Offshore Runway Construction Concepts

**Blue Ribbon Panel Review**

**FINAL REPORT**

**SAN FRANCISCO INTERNATIONAL AIRPORT**  
**OFFSHORE RUNWAY CONSTRUCTION CONCEPTS**

SAN FRANCISCO INTERNATIONAL AIRPORT  
EARTH FILL STRUCTURE CONCEPT  
TYPICAL IDEALIZED HALF SECTION

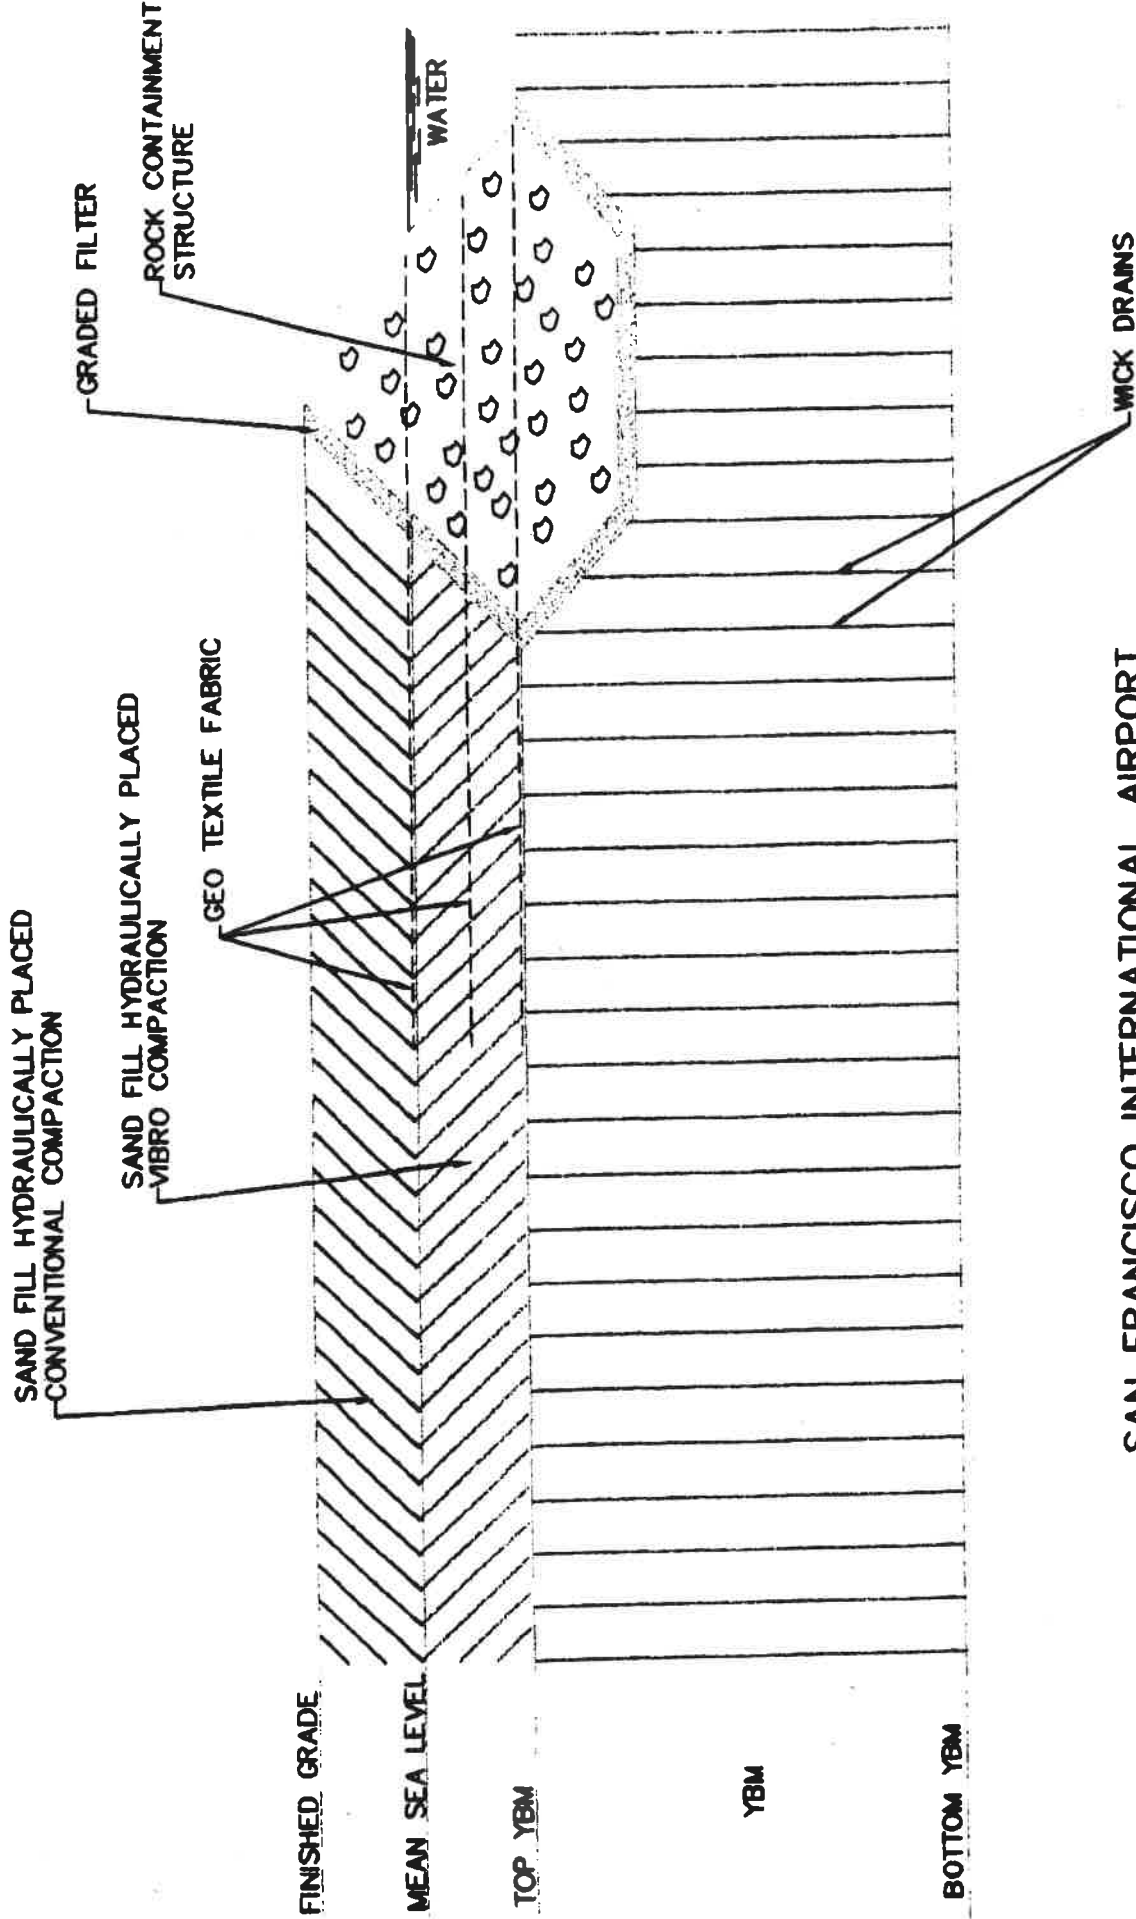
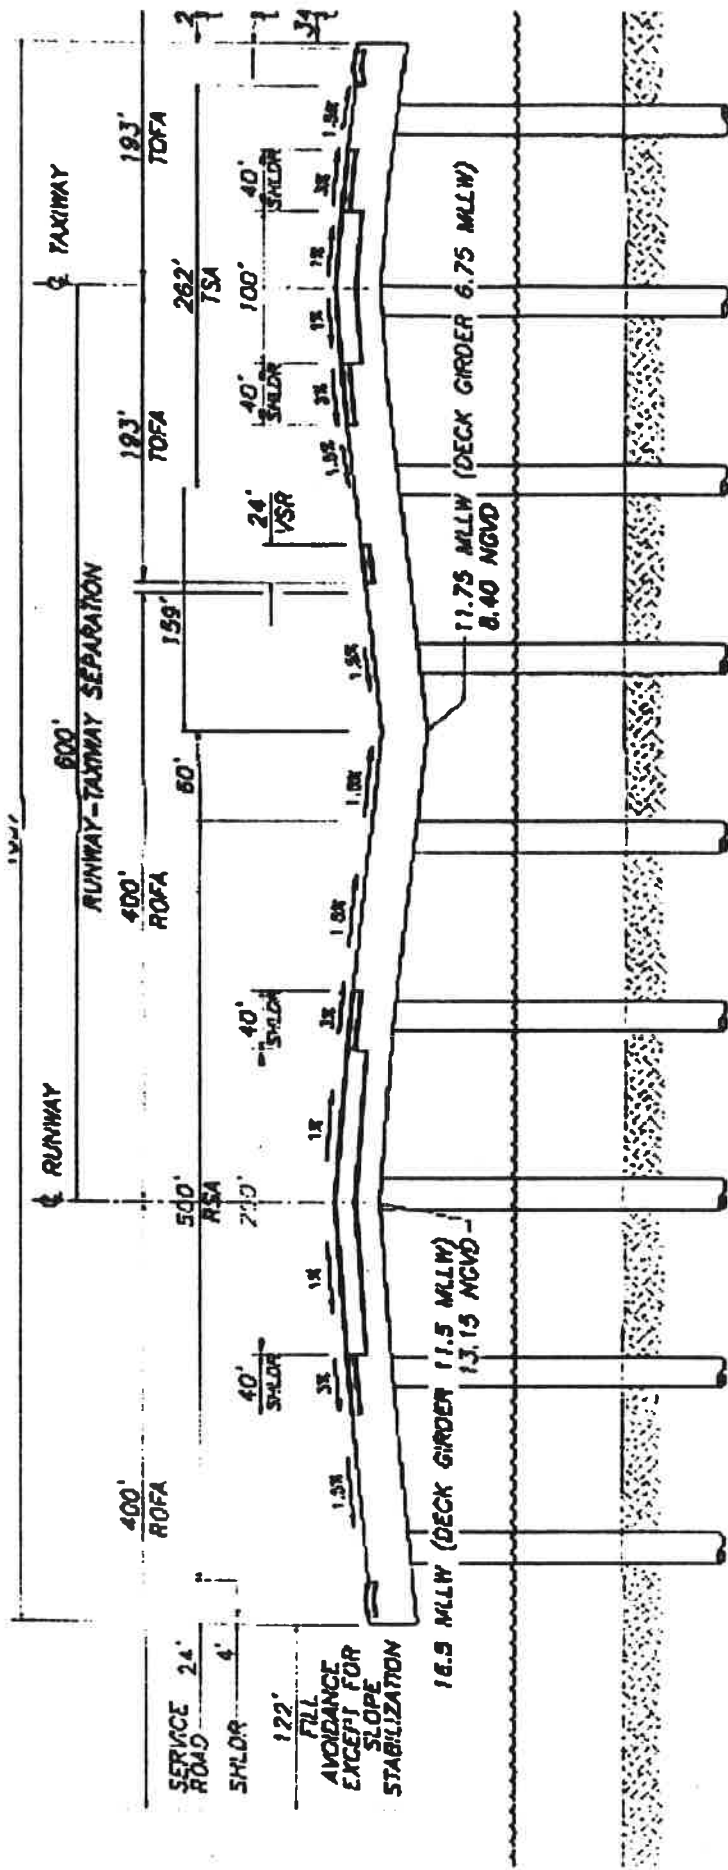
Containment - The perimeter retaining structure for all fill concepts are key components for overall stability of the structure for both static and seismic loading. An open cell sheet pile system as proposed by one consultant is not recommended due to concerns of performance under the large settlements anticipated and under major seismic events.

- Install wick drains under the dike so primary consolidation will occur early.
- Construct rock dike with adequate side slopes on both sides to provide adequate stability.
- Install two to three layers of geotextile membrane, not only in the rock dike, but extended into the dredged fill to increase stability.
- Construct a graded filter between the rock dike and the dredged fill to prevent infiltration of the fines from the dredged fill into the rock dike.
- Construct the rock dike early around the platform before placing the dredged fill to reduce turbidity in the Bay.

**PILE SUPPORTED STRUCTURE SECTION**

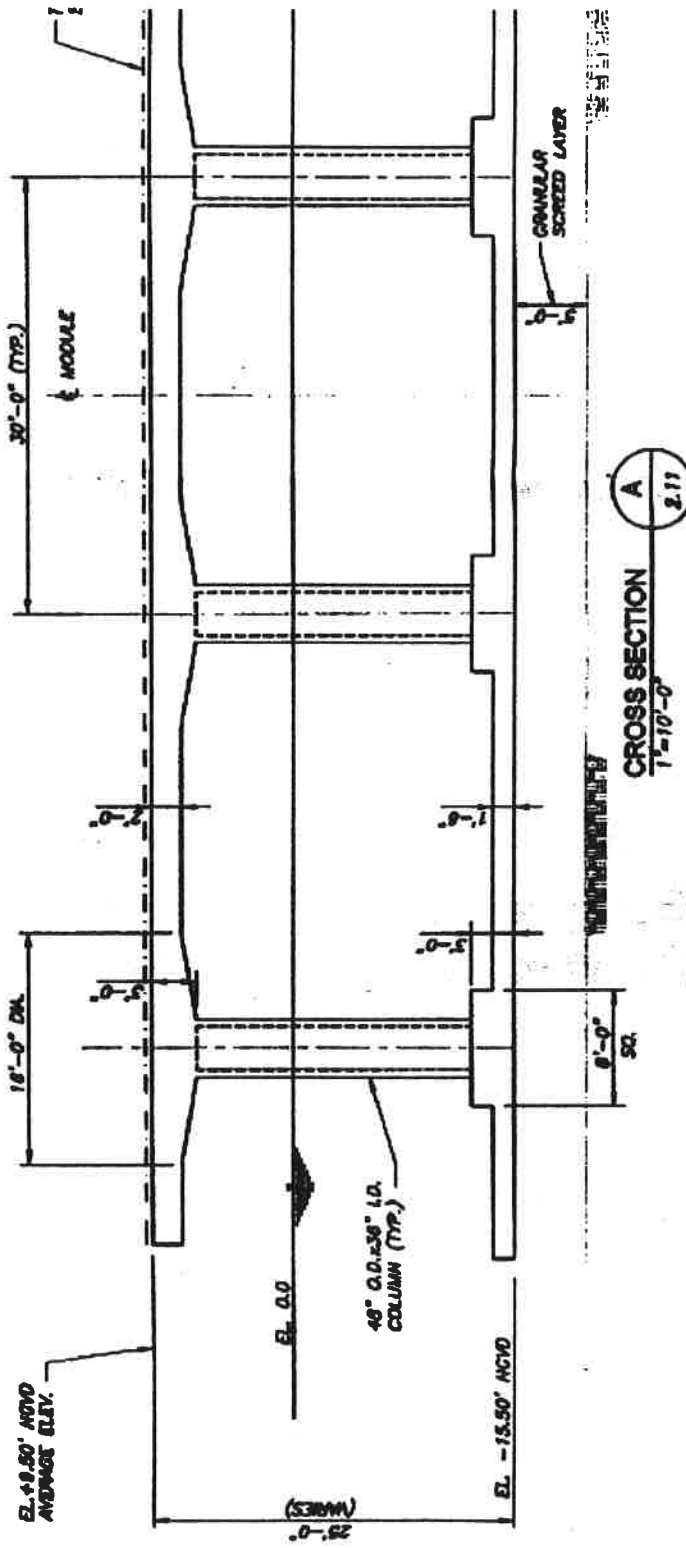
Steel piles, cast-in-place concrete piles, and precast concrete piles were all proposed. For steel piles, based on cost, availability and durability, there is a question of whether the procurement would all be in the United States. Durability, maintenance, construction and cost issues indicate that concrete (precast or cast-in-place) piles may be advantageous. The use of prismatic concrete piles may be considered. The production of precast piles may have to be done by several producers to minimize the impact on their other customers.

Construction/ Cost/ Schedule - Construction of PSS runways should maximize off-site precasting, yet allow for generous construction and assembly tolerances to minimize overall risk in terms of cost and schedule. A flexible runway pavement consisting of 8 to 10 inches of bituminous overlay will be required to allow for grade corrections. The flexible overlay is also needed to allow for grooving to prevent hydro-planing, and the installation as well as re-location of operational signs and lighting. All utilities, including drainage, water, sewer, electrical and control, will be located within or under the deck or superstructure and need to be fully accessible.
